## Appendix 1c - Proponent's supplementary Urban design information

## RESPONSE TO PROPOSED AMENDMENTS TO BUILT FORM. PREPARED BY BVN 30 AUGUST 2021

Council has appointed Design Inc to undertake an independent peer review ('Design Inc Envelope') of the Planning Proposal envelope and concept design prepared by BVN Architecture ('Current Proposal') for the Applicant. Phillip Rossington, Principal of BVN Architecture, has prepared the following response to the Design Inc recommendations.

**SECTION EAST-WEST**

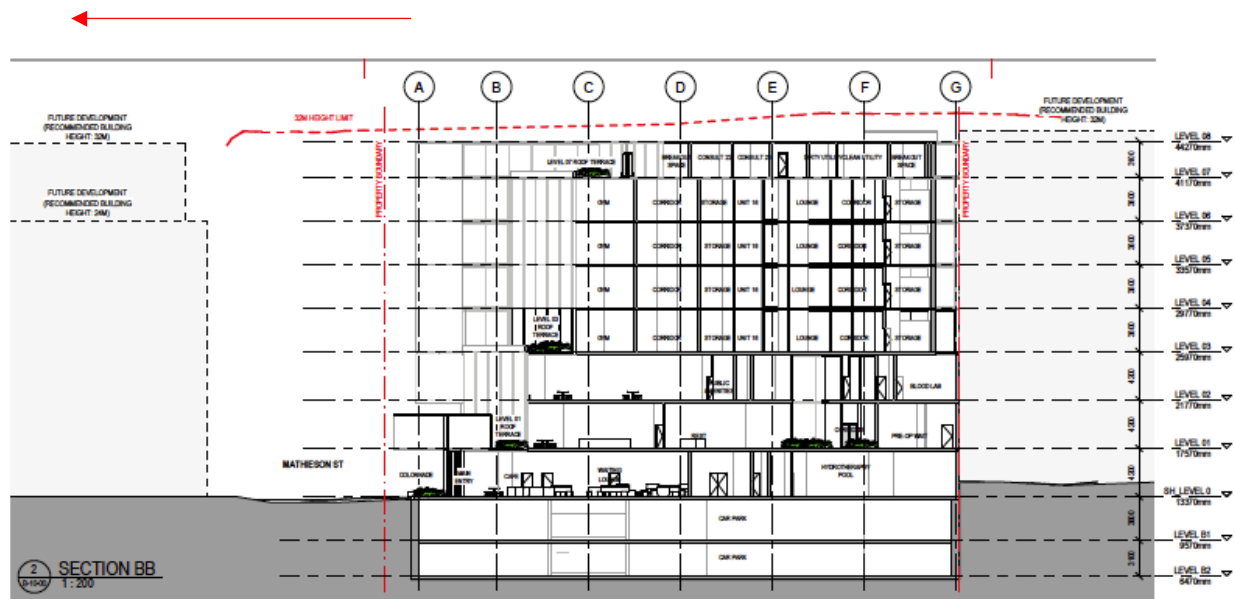
'Current Proposal' heights remain consistency with 32m height proposed immediately to the west (transition down occurs further west)

The 'Design Inc Envelope' however proposes a lowered height on the north west corner of the subject site. The intention of this was to assist in transitioning down to improve the relationship with future development to the north and west. We note the PRCUTS Design Guidelines already accommodates this transition by reducing the height on the Northern side of Cahill St to 16M. It is our understanding that the existing strata building to the North of Cahill St is wholly owned by one entity.

**SECTION EAST-WEST**

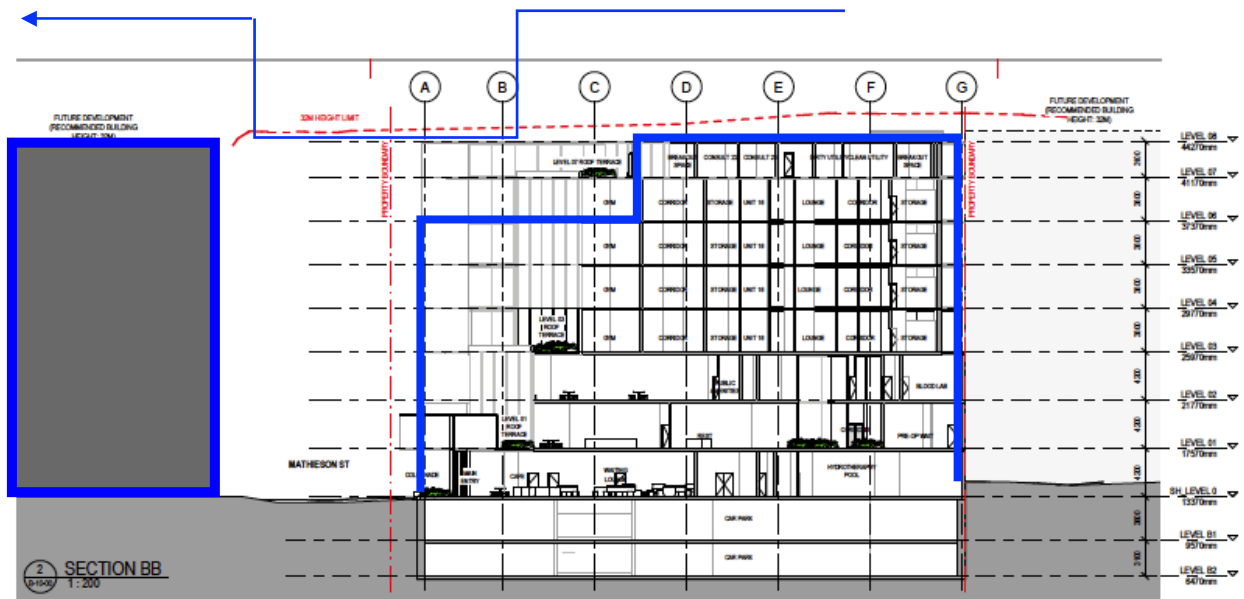
The east-west section highlights the inconsistency with the future development immediately to the west.

'Design Inc Envelope' lowered height in the NW corner would create an inconsistent relationship with 32m height proposed immediately to the west

210824. OVERLAY OF DESIGN INC PROPOSED FOOTPRINT - GROUND FLOOR

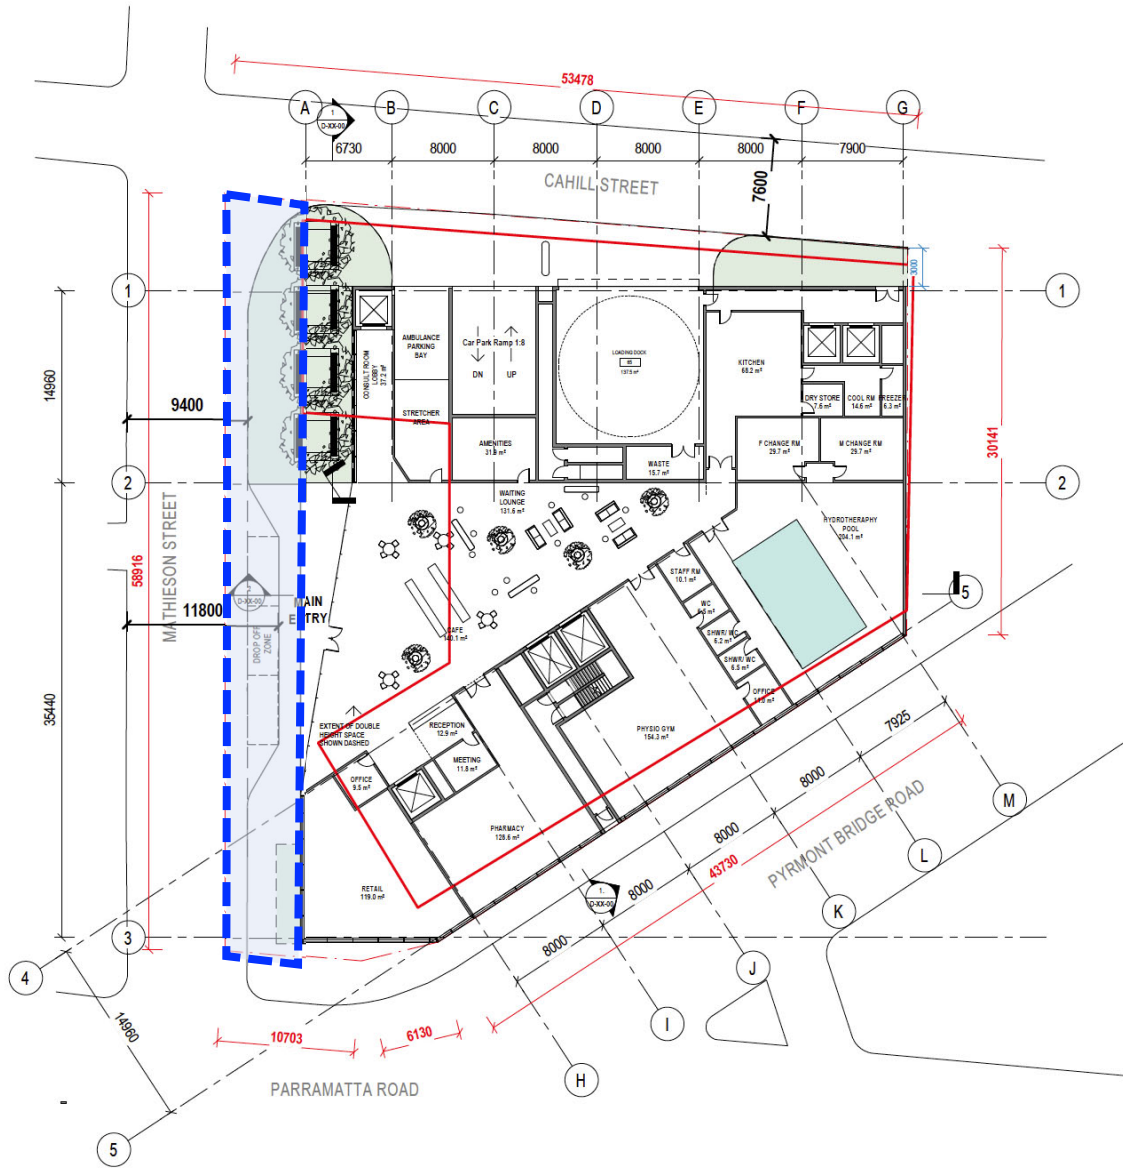
An overlay of the 'Current Proposal' and the 'Design Inc' envelope is included below. A nominal zone to demarcate a revised site boundary is highlighted in blue below. Requirements to include a 'forecourt' to the entrance can be written into the site specific DCP.

### SOLAR STUDY - FUTURE DEVELOPMENT

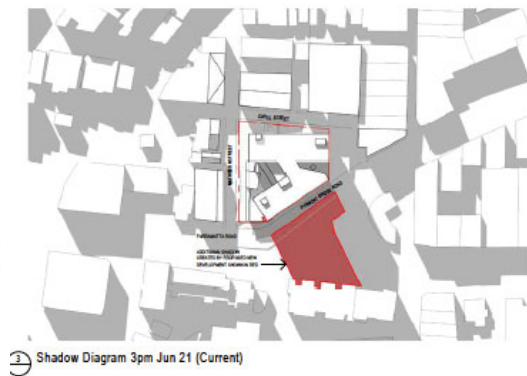
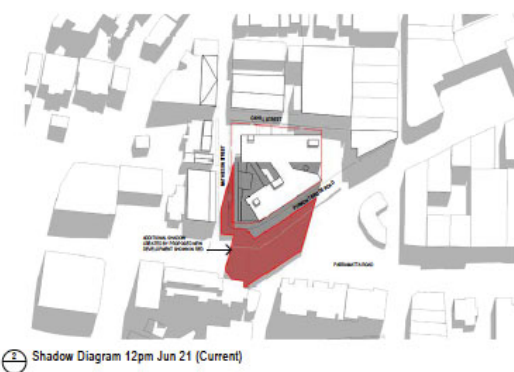
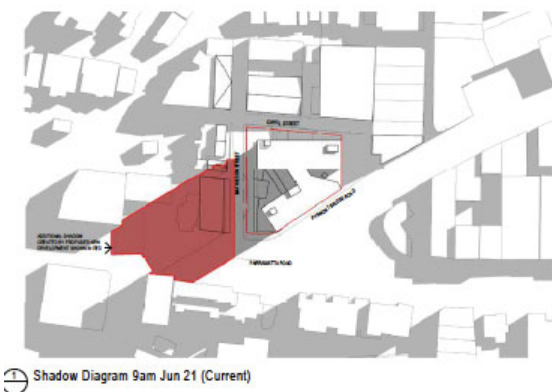
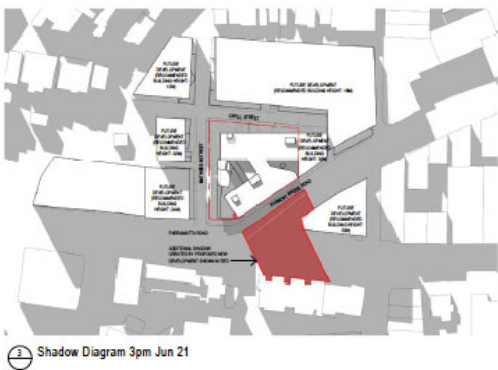
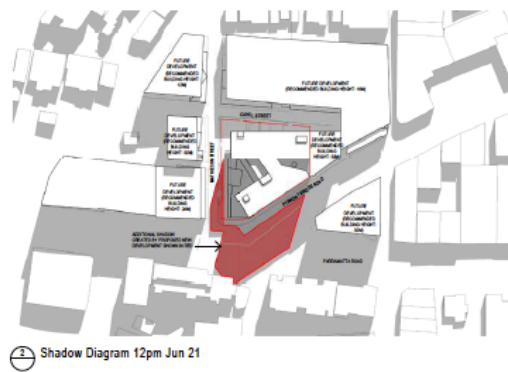
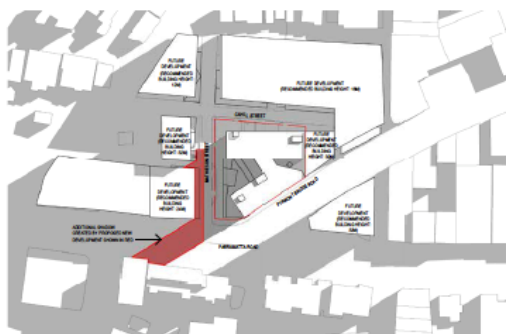
Relating to commentary on the height above, we believe the shading created by the 'Current Proposal' is acceptable. Reducing the height to a northern element of the building will not increase solar access to any buildings to the south or the public domain.

## 6.0 BUILDING USEABILITY AND FUNCTIONALITY

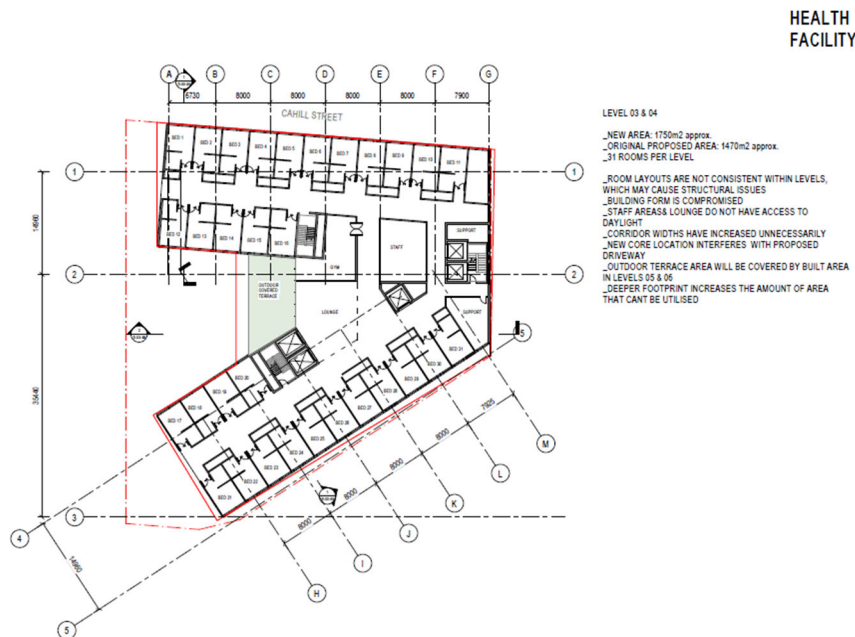
Floorplate testing undertaken by BVN demonstrates the 'Design Inc; envelope may not necessarily be suited or add value to the low-mid rise, and that the reduced footprint of the high rise floorplates will inhibit the building to be usable by the intended end user group of the facility.

BVN assessment of low-mid rise floors with comments listed to the right hand side. This arrangement increases the corridor / circulation space, the intended user has indicated that this extra space is not required on these floors.

### HEALTH FACILITY

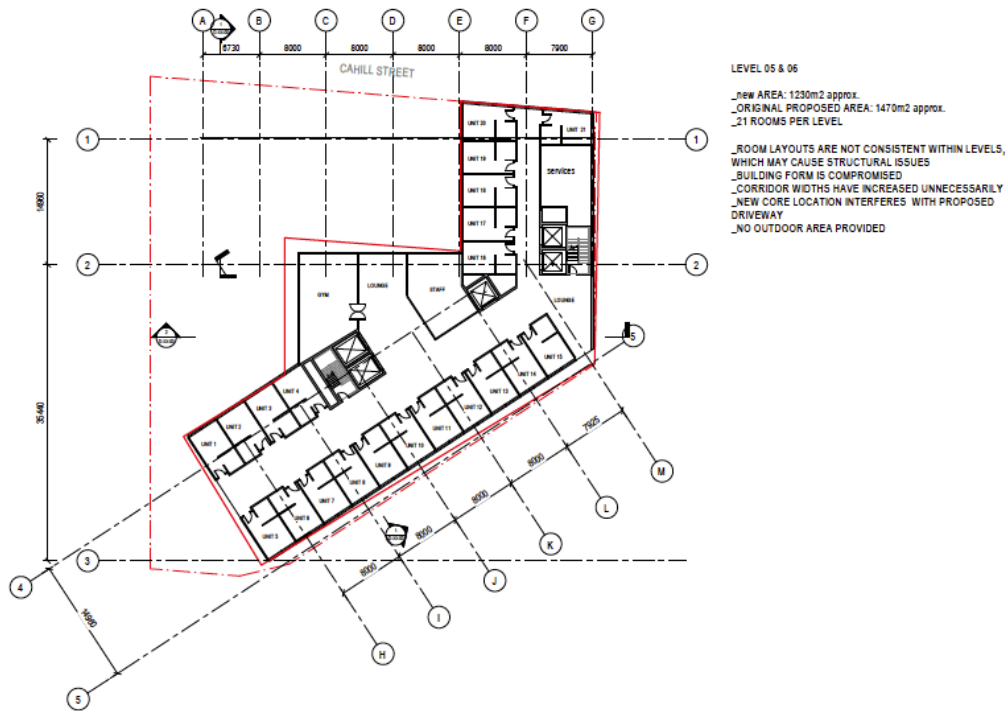
The transition from larger to smaller high rise floorplates are undesirable as the built form is compromised and the floorplates are too deep and inefficient (oversized corridor widths).

The building floorplates for the purposes of the end user group would need revert back to what was proposed in the 'Current Proposal' and as such the full extent of the 'Design Inc' floorplate would not all be usable floorspace (resulting in potentially less than the 4:1 FSR prescribed for the site). An outline of the 'Design Inc' envelope and the 'Current Proposal' floorplate including efficient and usable floorplates is illustrated below. If this occurs, the remaining floorspace on the high rise floors isn't sufficient to accommodate end user group's total requirements (10,280m<sup>2</sup> GFA).
